**2<sup>nd</sup> Further Information**

**Proposed Temporary Warehouse (Excluding Dangerous Goods Godown) with Ancillary Facilities  
for a Period of 3 Years and Associated Filling of Land and Pond in "Agriculture" Zone,  
Various Lots in D.D. 107 and Adjoining Government Land, Fung Kat Heung, Yuen Long**

**(S.16 Planning Application No. A/YL-KTN/1023)**

**Responses-to-Comments**

DRAWING TITLE  
 OPENABLE WINDOW AREA CALCULATION FOR STRUCTURE

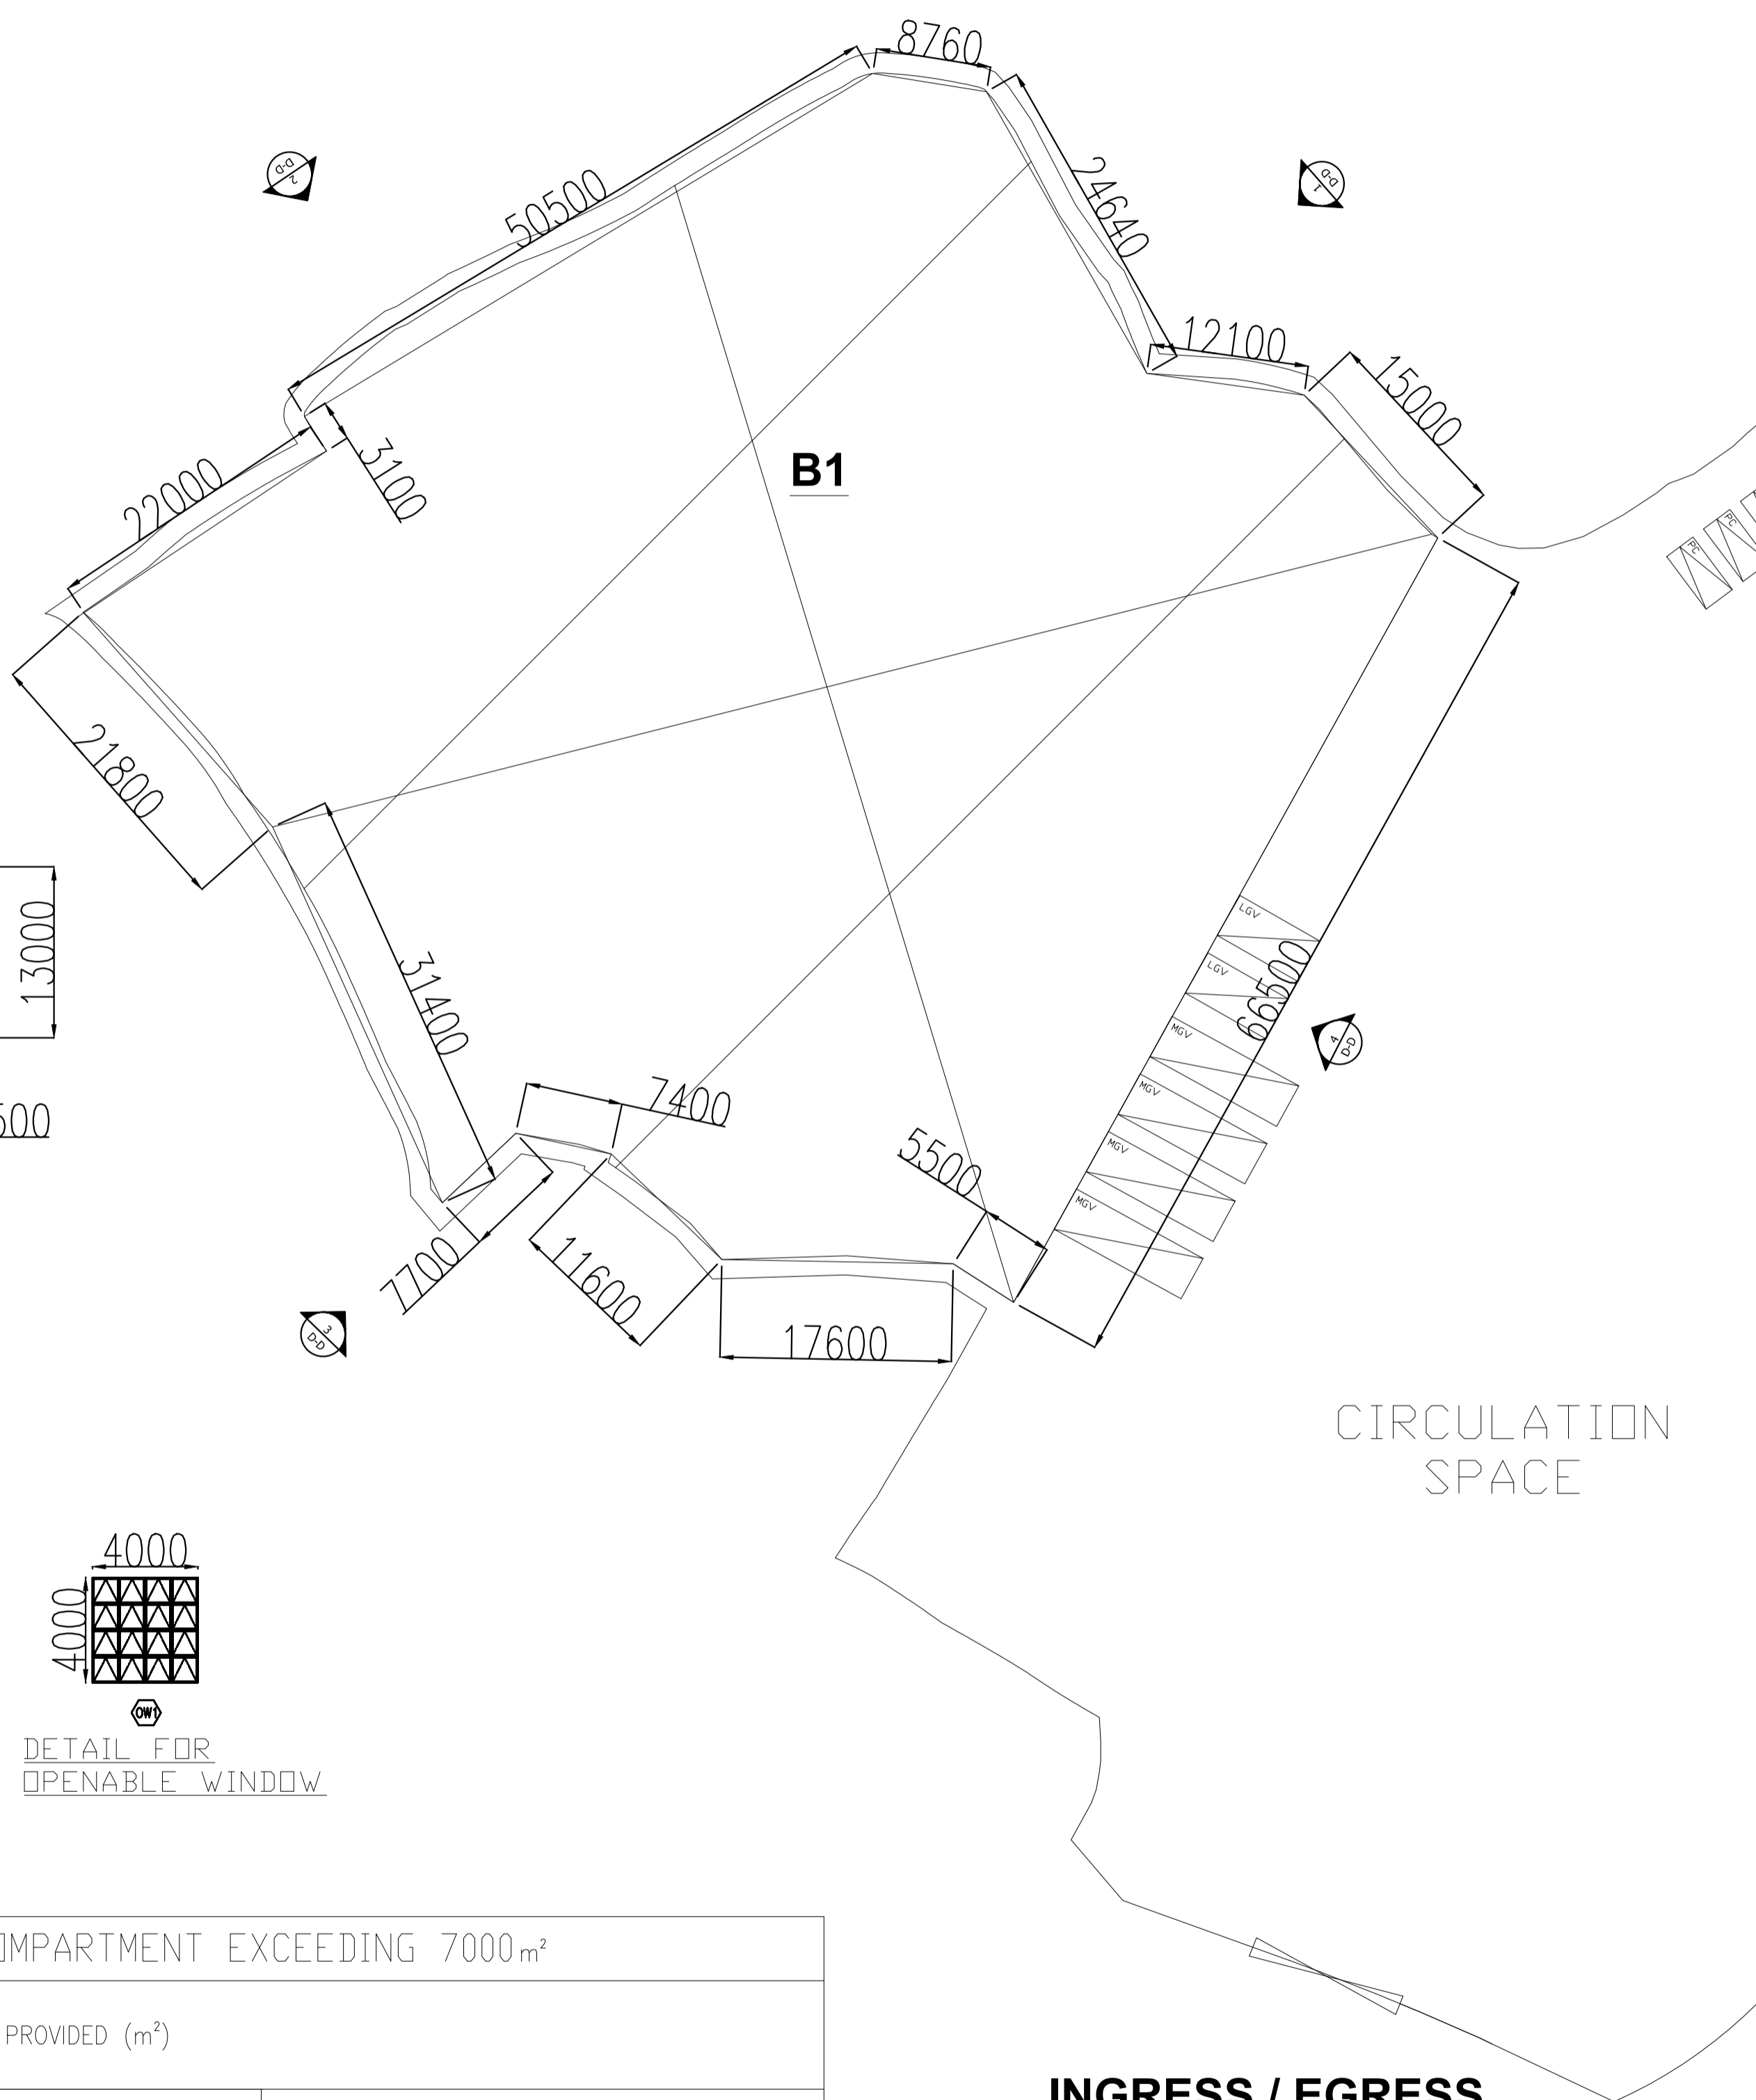
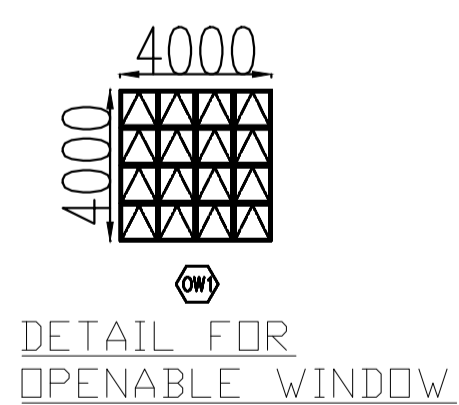
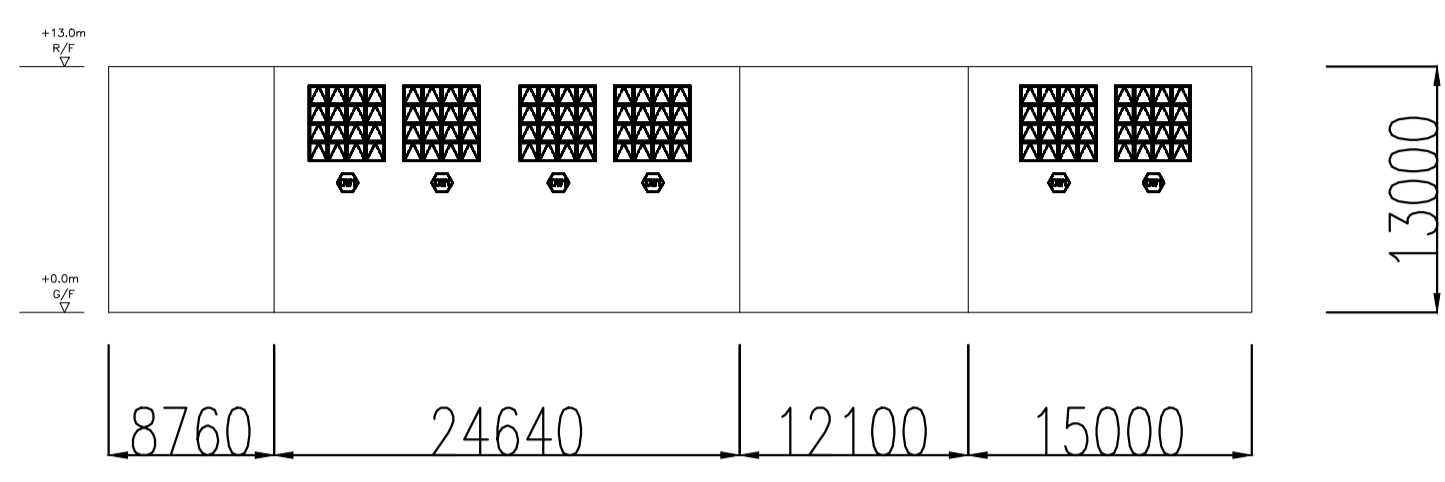
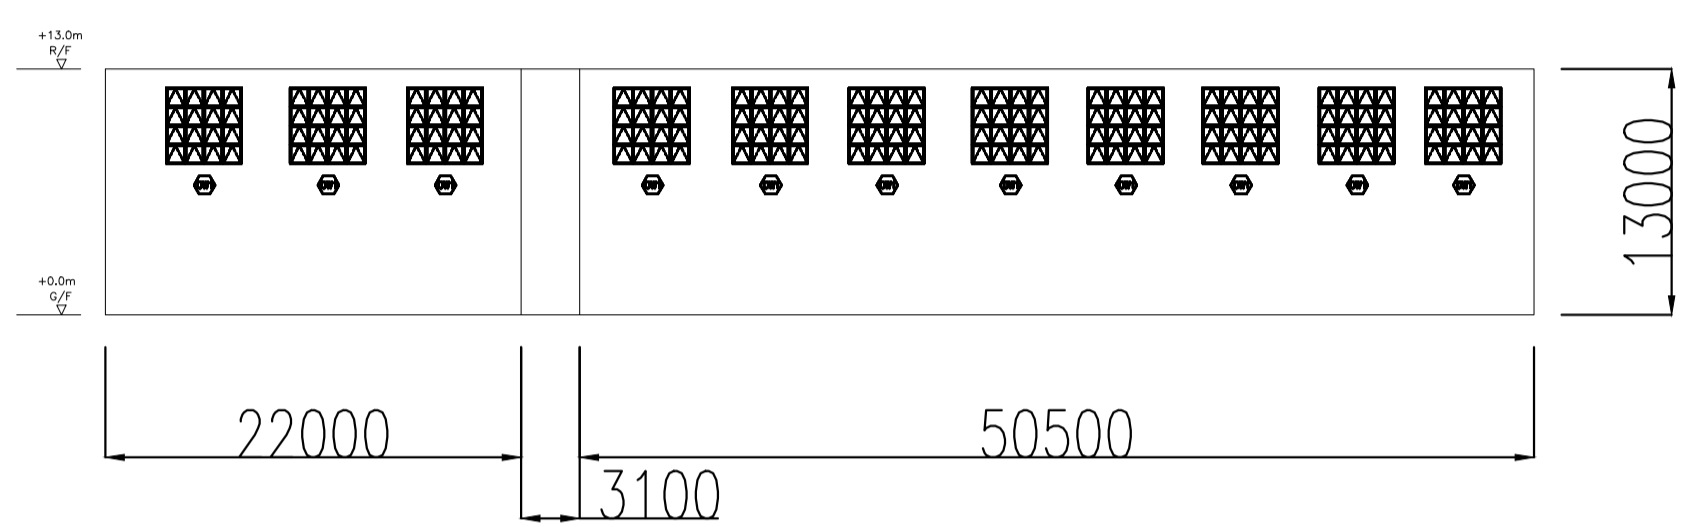
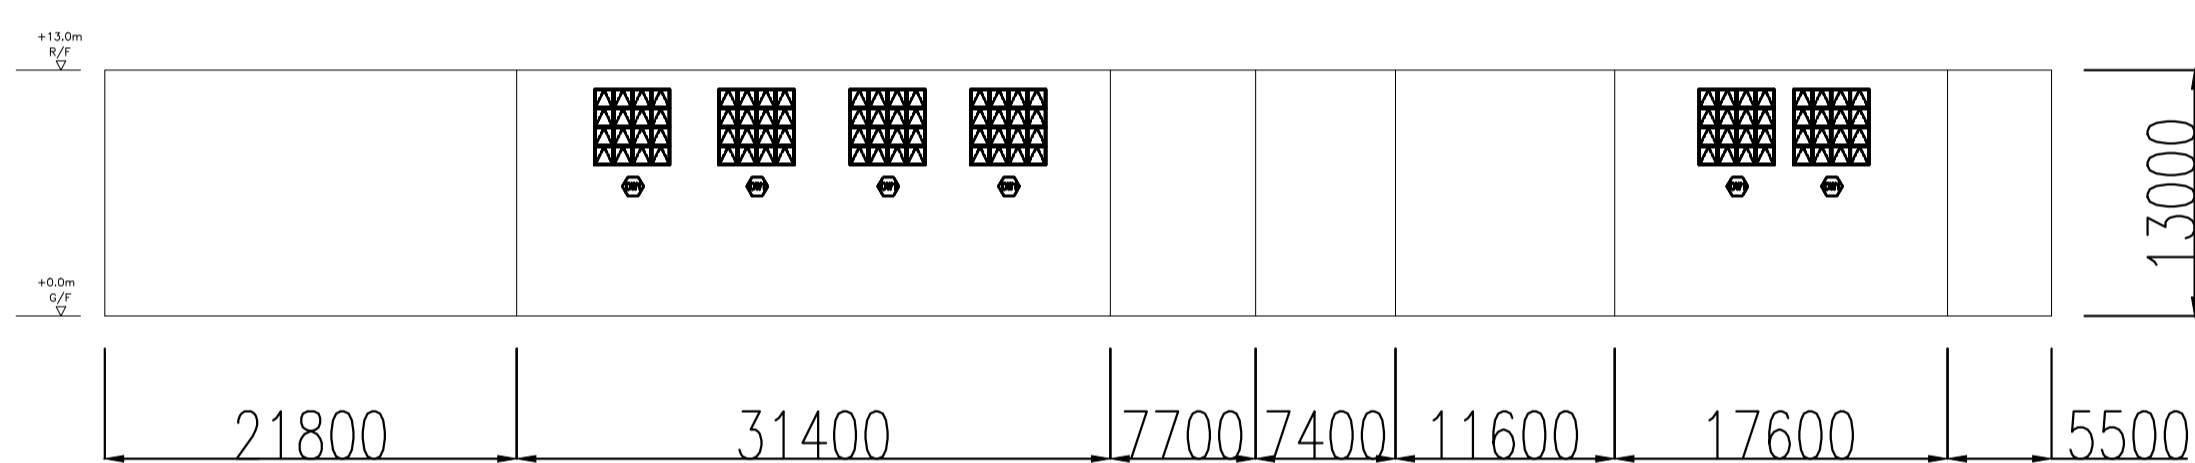
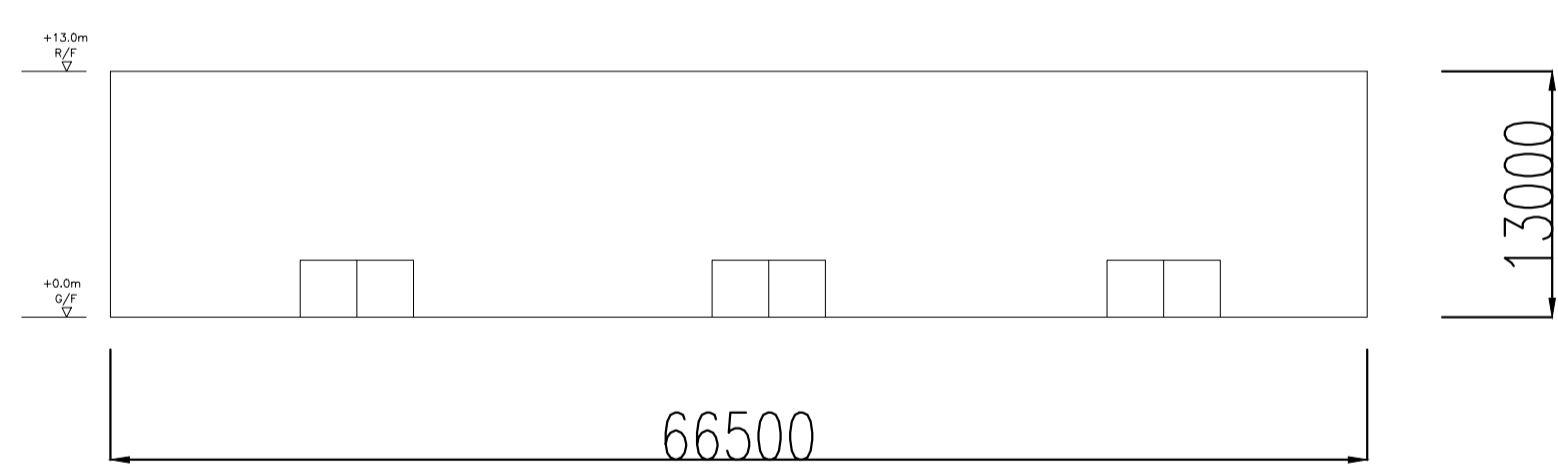
(d)	Justifications for the non-provision of smoke extraction system to Structure B1, i.e. "Smoke extraction system shall not be provided to structure B1 as the aggregate area of openable windows exceeds 6.25% of the floor area of the structure B1" shall be specified in the FS Notes 8.1;

- 8 STATIC OR DYNAMIC SMOKE EXTRACTION SYSTEM
  - 8.1 SMOKE EXTRACTION SYSTEM SHALL NOT BE PROVIDED AS THE AGGREGATE AREA OF OPENABLE WINDOWS OF THE COMPARTMENT SHALL PROVIDE MORE THAN 6.25% OF THE FLOOR AREA OF THAT COMPARTMENT.

OPENABLE WINDOW AREA CALCULATION UNDER F.S.D. REQUIREMENT FOR COMPARTMENT EXCEEDING 7000m <sup>2</sup>				
LOCATION	USABLE FL. AREA (m <sup>2</sup> )	OPENABLE WINDOW AREA REQUIRED (m <sup>2</sup> )	OPENABLE WINDOW AREA PROVIDED (m <sup>2</sup> )	
STRUCTURE B1	<u>5648</u>	<u>5648 X 6.25% = 353</u>	REFER TO ELEVATION 1 = 96 REFER TO ELEVATION 2 = 176 REFER TO ELEVATION 3 = 96	TOTAL = <u>368</u> > <u>353</u>

Title  
**DRAINAGE LAYOUT PLAN - UNPAVED AREA**

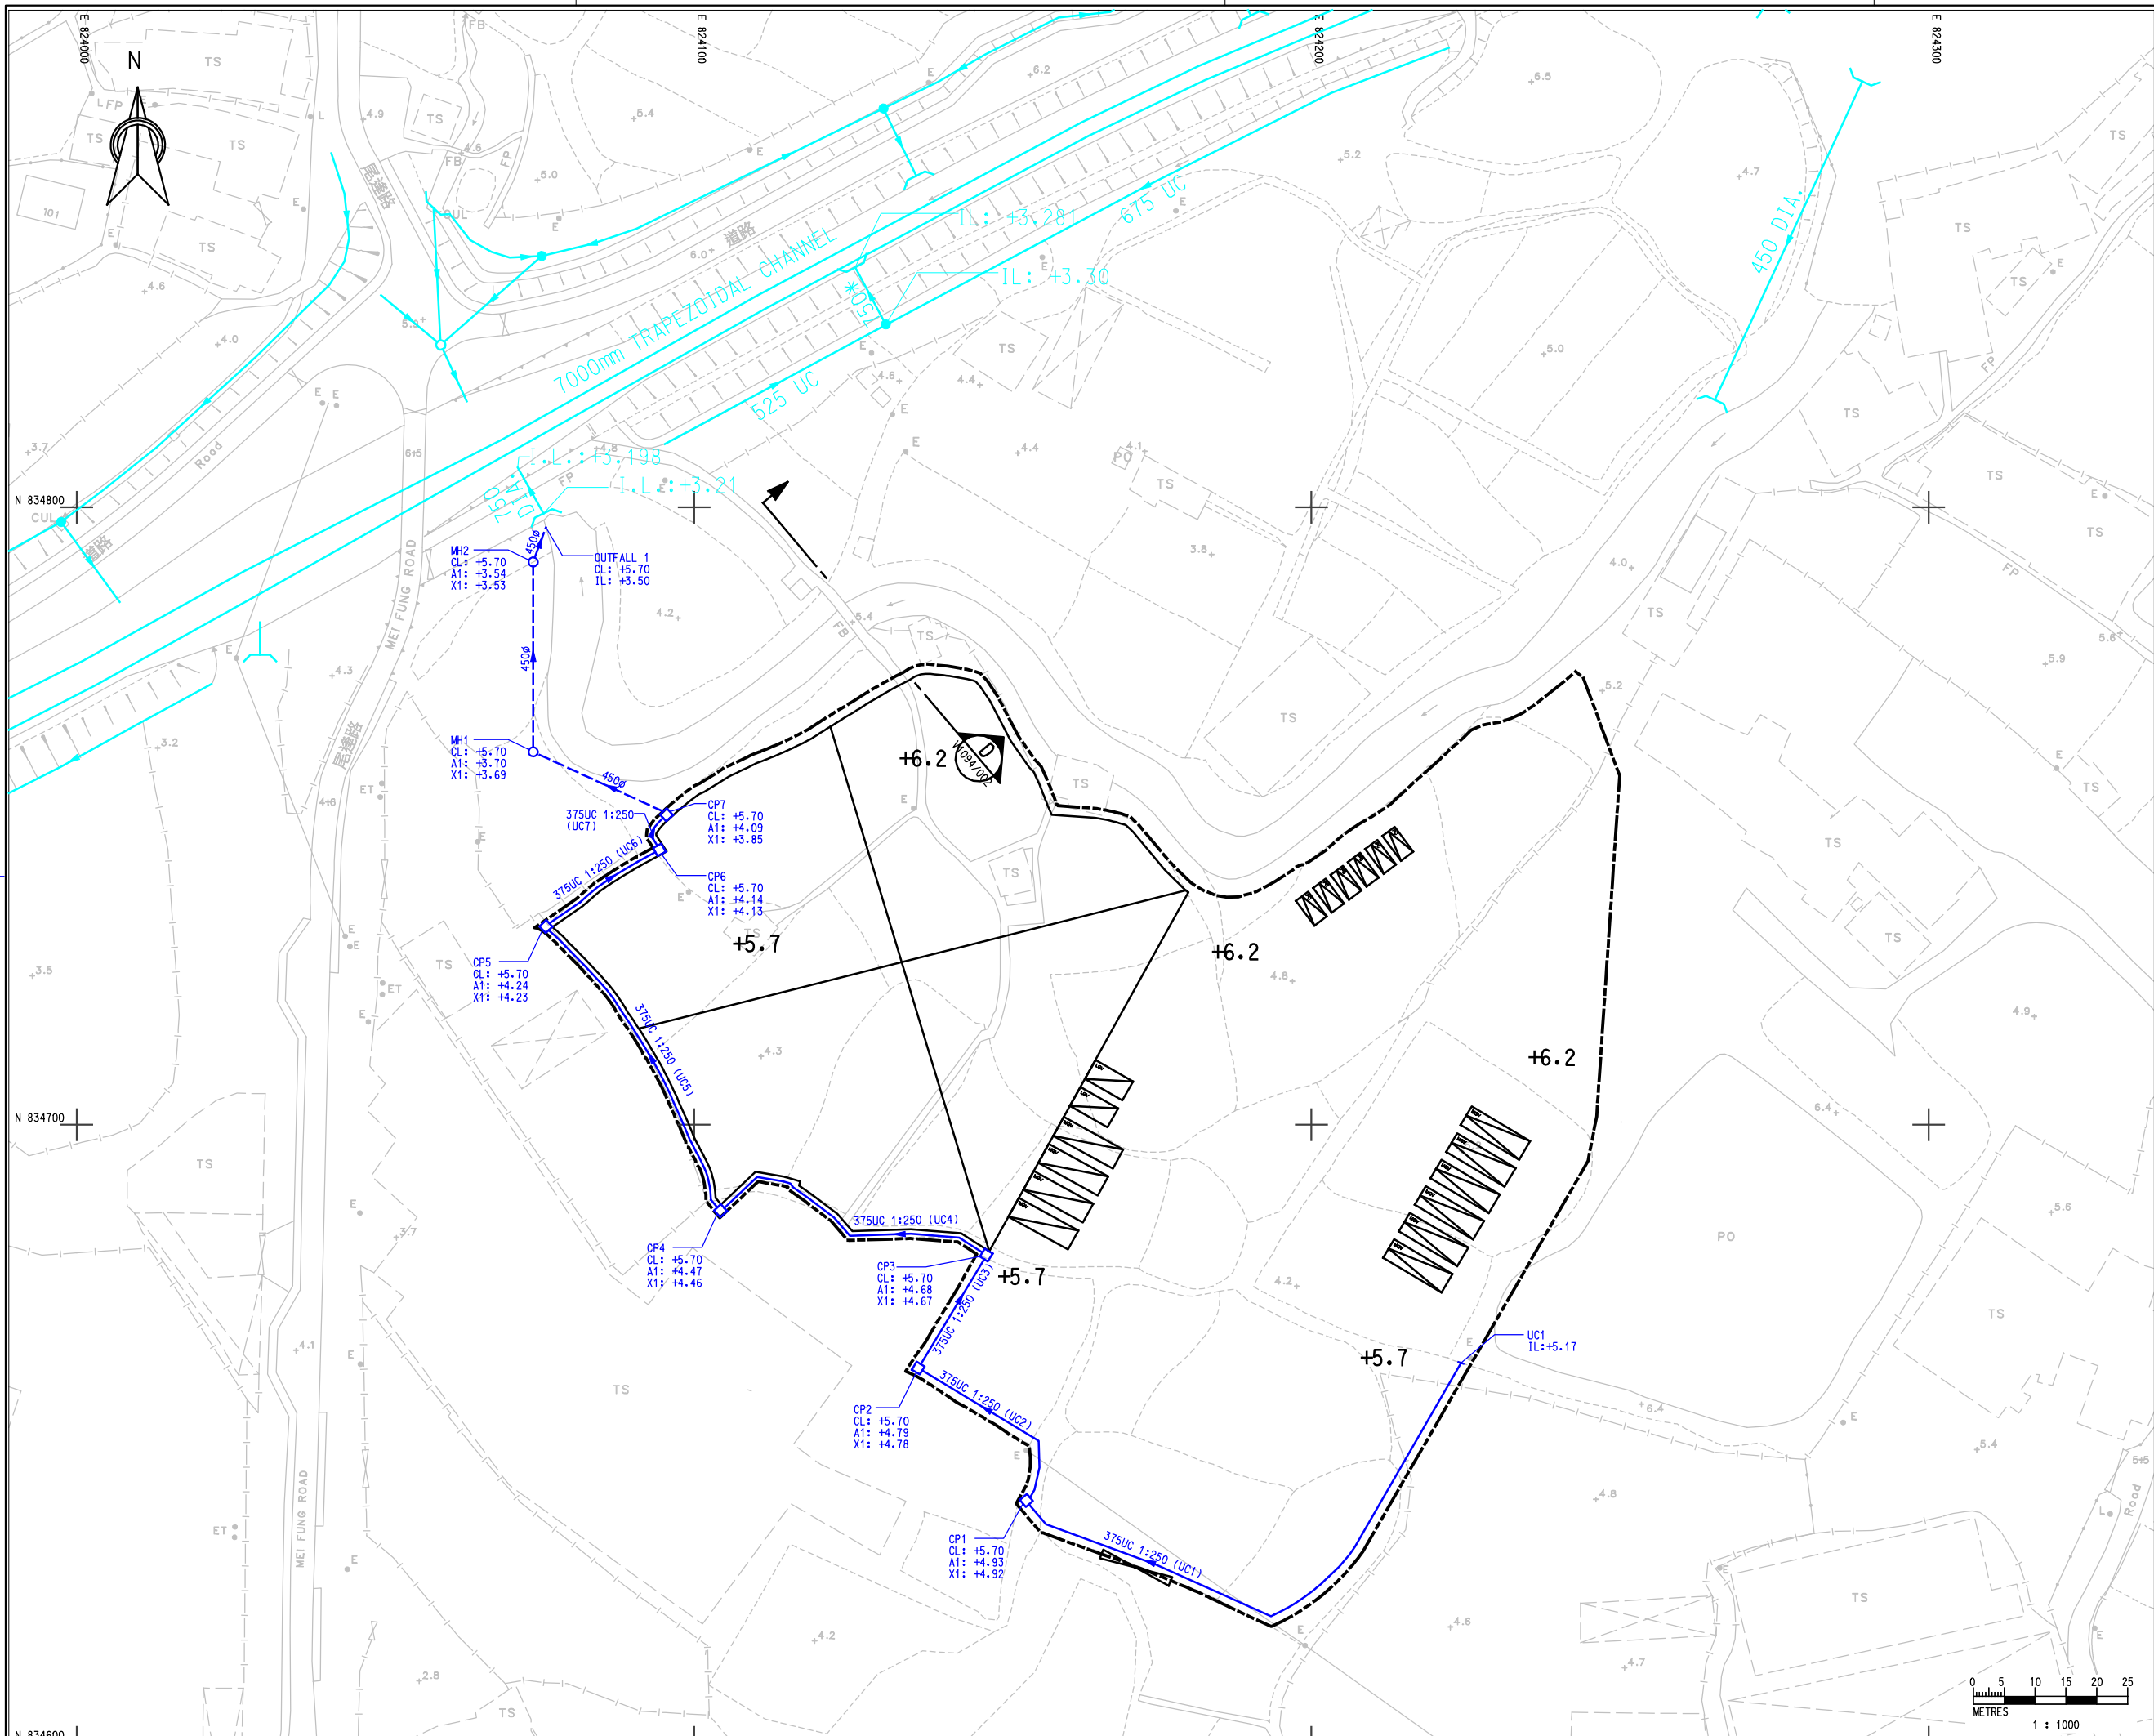
(a)	The DIA should be signed and certified by a qualified engineer (Registered Professional Engineer in the Civil Engineering discipline) before it is submitted to DSD for comment.	A revised drainage impact assessment report, which signed and certified by the qualified engineer, has been submitted by the applicant to review the drainage arrangements for the proposed development ( <b>Annex II</b> ).
<b>3. Comments of the District Planning Officer/Fanling, Sheung Shui and Yuen Long East, Planning Department (DPO/FSYLE, PlanD)</b> <b>(Contact Person: Ms. Andrea YAN; Tel.: 3168 4049)</b>

- 3.6 The 375mm U-channels are proposed at south of the Site. The runoff from the unpaved area in the Site (i.e. Catchment Area Nos. D) would be collected by u-channels and drain to outfall 1 by gravity via 450mm dia. drainage pipes. Drainage layout plan and details of drainage are shown in **Drawing Nos. V1094/003** and **V1094/007** in **Appendix A**.
